# International Isotopes Inc.

Subject: Request to Amend NR-1235-S-103-S.

International Isotopes Inc. requests to amend Registry of Sealed Sources and Devices Safety Evaluation of Sealed Source Number NR-1235-S-103-S to include a range of sources capsules between the current dimensions of the Model INIS-SF-CS-1J and INIS-SF-CS-2J.

Model Numbers INIS-SF-CS-1J and -2J

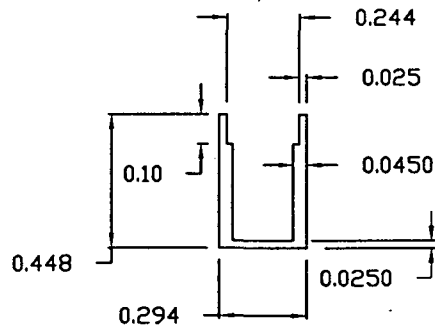
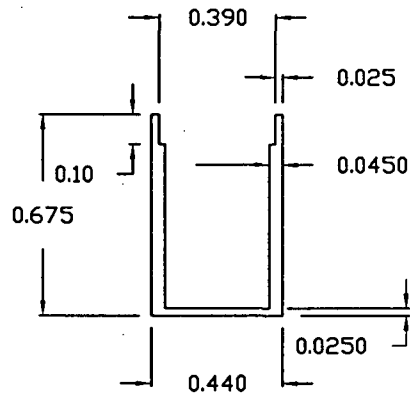
DESCRIPTION: Revise the dimensions table as follows:

Dimensions: Models INIS-SF-CS-1J and INIS-SF-CS-2J						
Maximum Outer Diameter (inches)	Minimum Outer Diameter (inches)	Maximum Length (inches)	Minimum Length (inches)	Wall Thickness (inches)	Bottom Thickness (inches)	Cap Thickness (inches)
0.294 ± 0.005	0.440 ± 0.005	0.448 ± 0.005	0.675 ± 0.005	0.045 ± 0.005	0.025 ± 0.005	0.055 ± 0.005

The drawing has been revised and is attached.
